UNITED STATES PATENT AND TRADEMARK OFFICE

Office Action Summary

09/883,851

DETAILED ACTION

Figure 8. Layout of the API laboratory at STL.

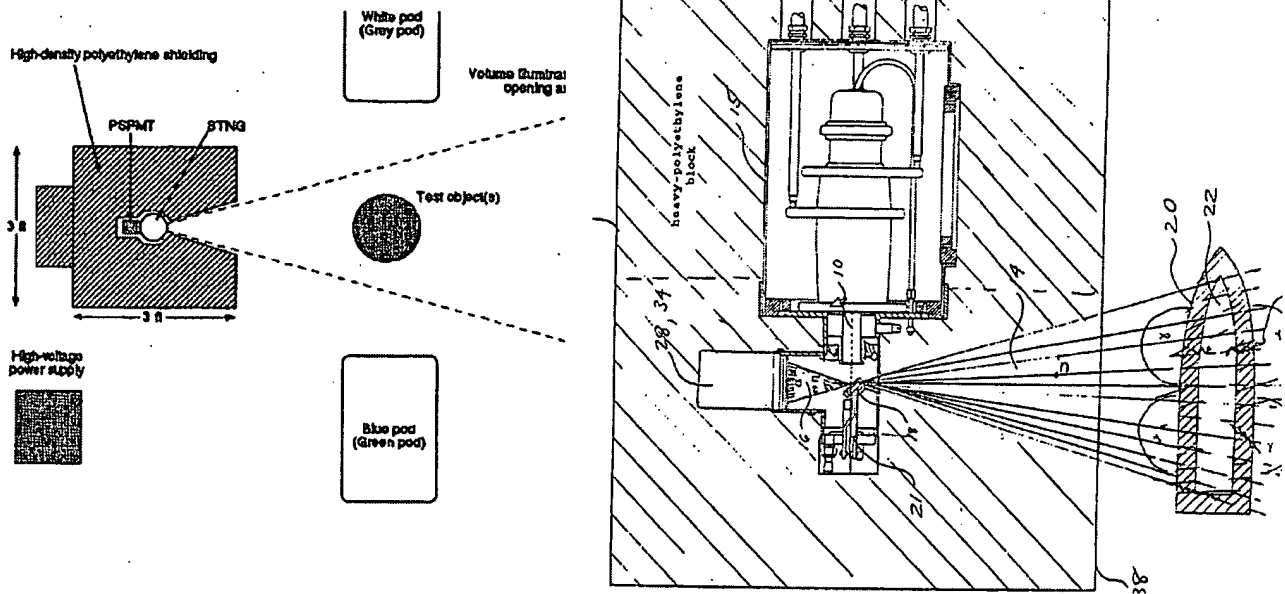
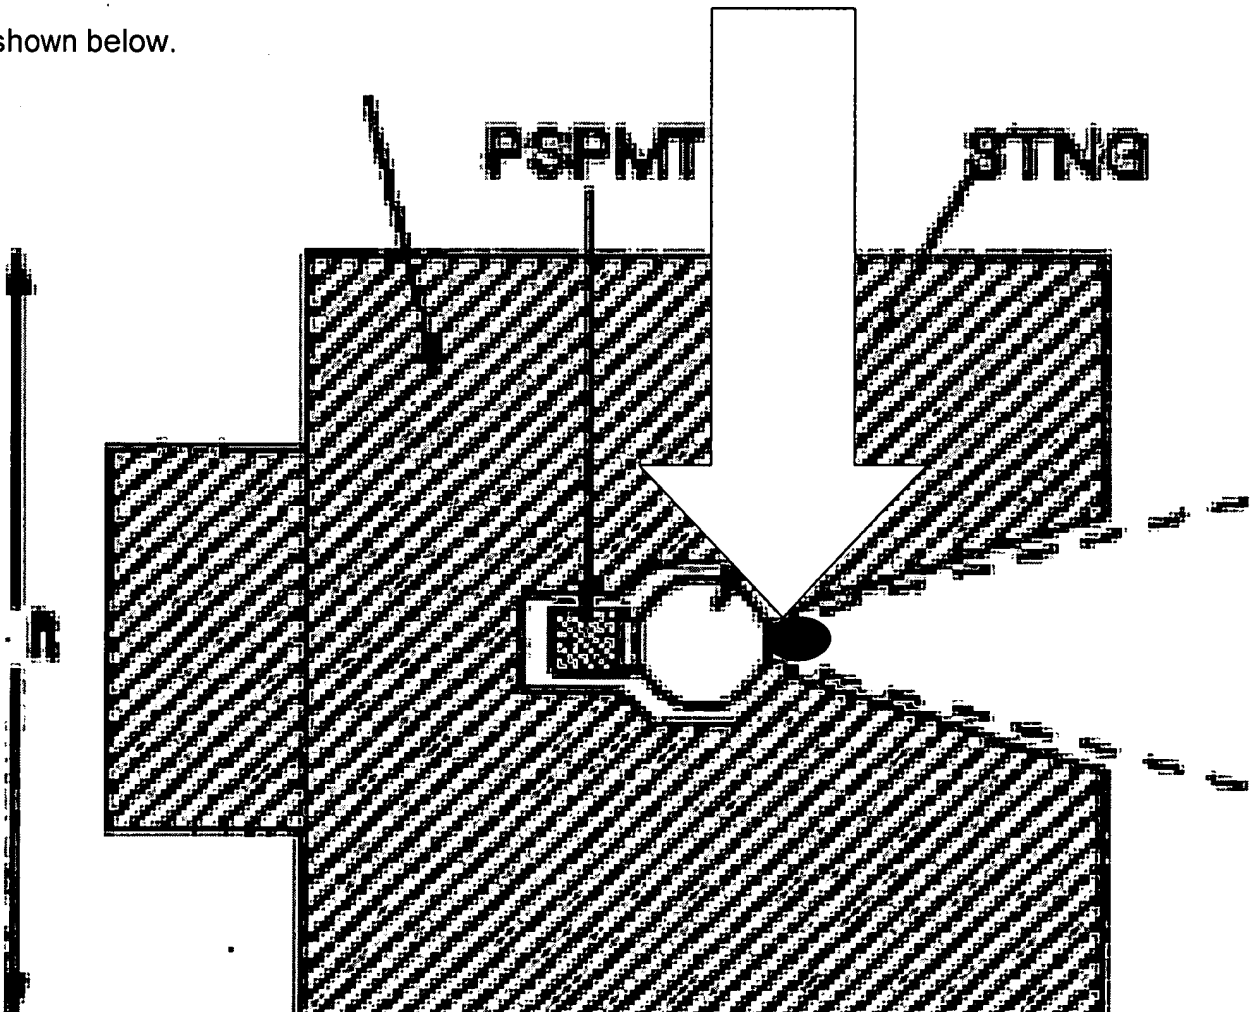
RESPONSE: Applicant appears to be singling out one figure of the Bechtel reference in order to support his position of the argument. However it is considered that applicant himself has the same issues with his own invention. For example, a comparison of figure 8 of the Bechtel reference and Figure 1 of Applicants own invention is shown below. Note how they both have polyethylene shielding.

There is no reason why the target material of Figure 8 cannot be located in the same position as claimed in applicants claim 1 by merely moving the target closer as shown below.

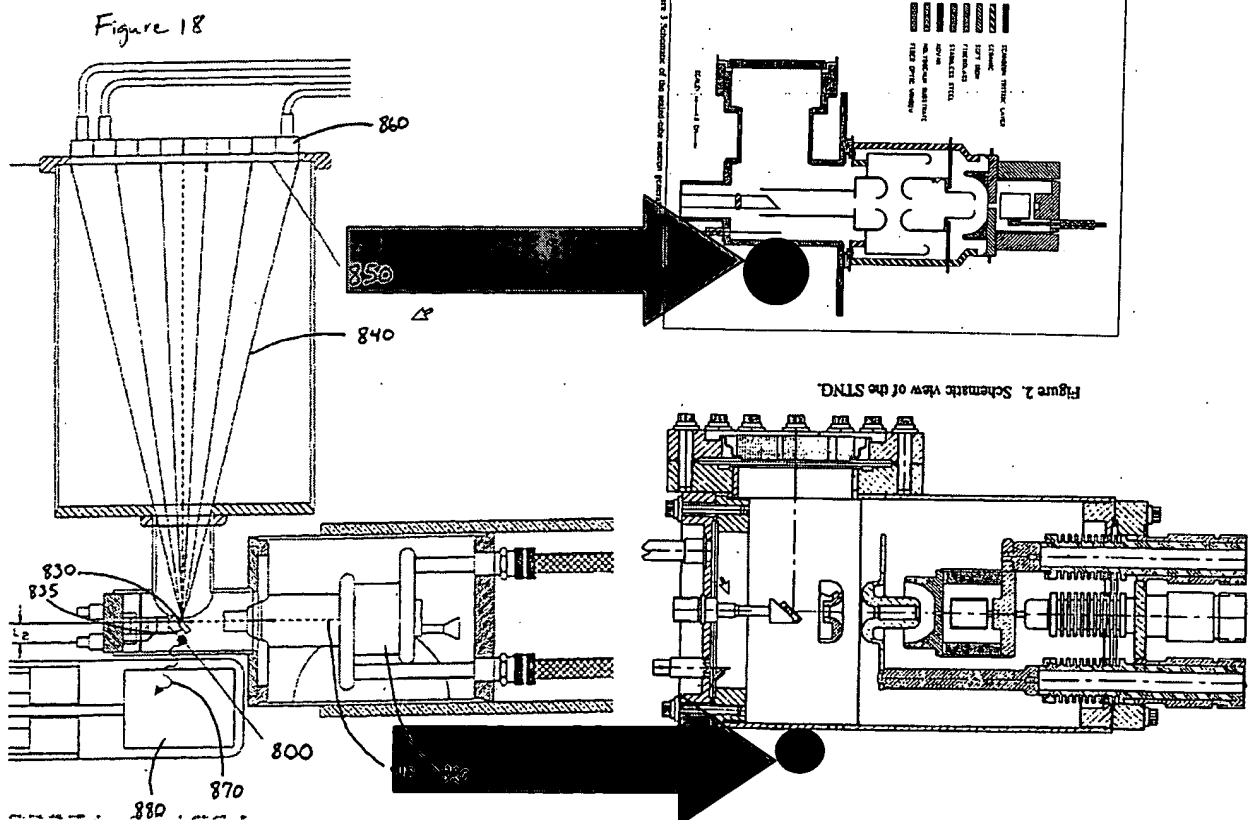
For another way to explain how the reference is inherently capable of being situated as applicant claims, let's turn to Figure 18 of Applicant's invention, Figure 2 of the Bechtel reference and figure 3 of the Hurley reference (Current Status of the Associated Particle Imaging system at STL, 1992) (both of which have been rotated to allow ease of viewing corresponding features. Note that the Bechtel reference is a later report of the Hurley reference and as such the figures are considered synonymous and/or interchangeable as representations of the inventions disclosed therein. Clearly, if the black dots shown below are the material to be analyzed, then the distance between the target material and particle detector array is indeed larger than the distance between the target position and the material to be analyzed.

Again, the Bechtel reference is indeed inherently capable of being positioned as claimed.

The STNG tube of the Bechtel reference and section 2.1 of the Hurley reference.

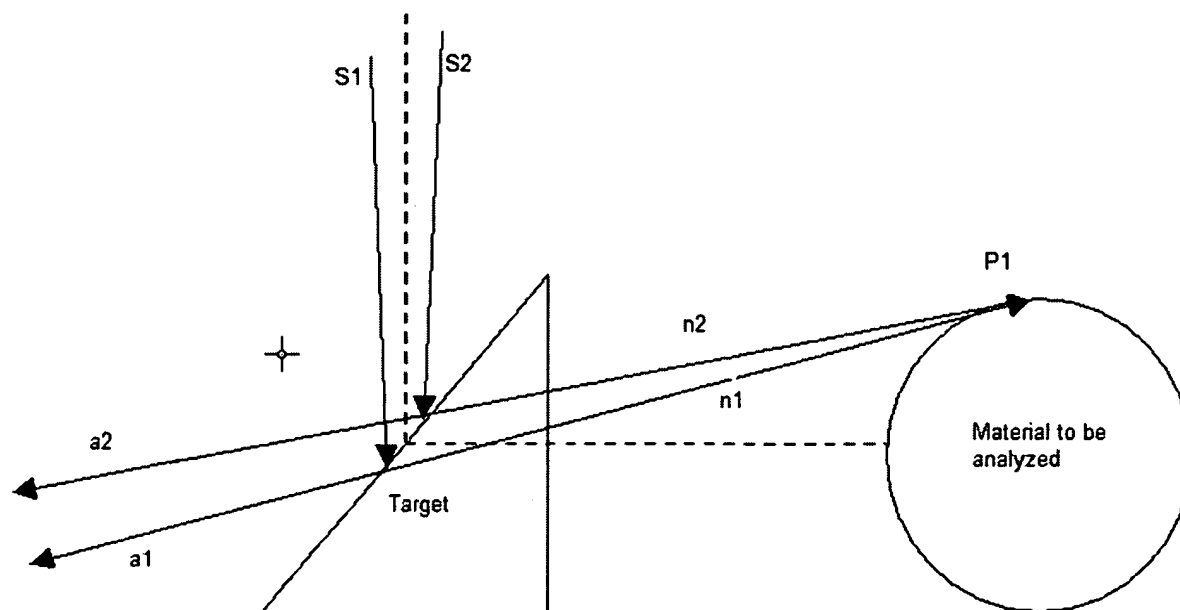
b. Claims 1 and 5 set forth that the material to be analyzed is closer to the target material than the particle detector array that deciphers the alpha emissions coordinates, however applicant has failed to set forth how and in what manner imaging may be possible at all. Applicant states (see page 25 of the specification) that the material to be analyzed is placed in the target box with a distance of .3cm, i.e. 3mm however the specification is silent as to how such is possible. It is the examiners contention that such is indeed NOT possible nor feasible. For example, it is impractical to locate a material to be analyzed that close to the target material because if said material is not within the APSTNG then it stands to reason that the walls of the APSTNG are at least that close to the target material. This does not appear possible due to the potential of voltage breakdown between electrode structures and the walls of the tube. That is, the

electrode and voltage requirements necessary to encourage the D-T reaction to produce neutrons put a lower limit on the tube dimensions. See section 4.1.1

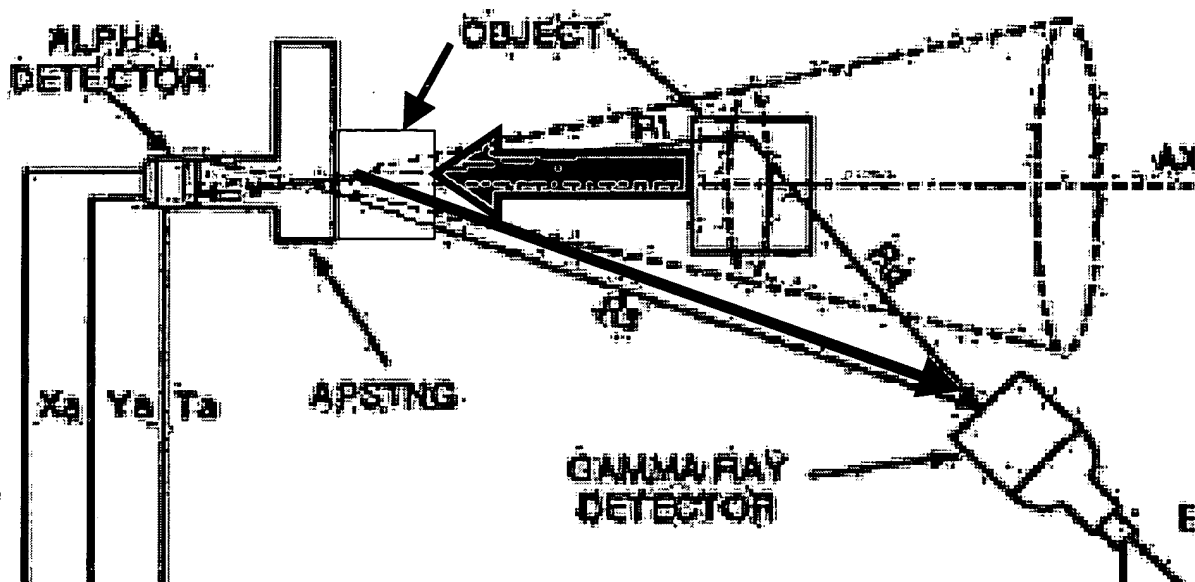
Again, the examiner has already addressed the issues of the distances and filtered electrical signals in section 19 above and incorporates said section 19 herein. Further as shown by the enlarged section of Figure 2 below, Rhodes is inherently capable of being used in the same manner claimed as applicant regarding the distances by merely moving the material to be analyzed closer to

the APSTNG. Again, this reference is inherently capable of being used in the manner set forth in the claim and the capability need only be present.
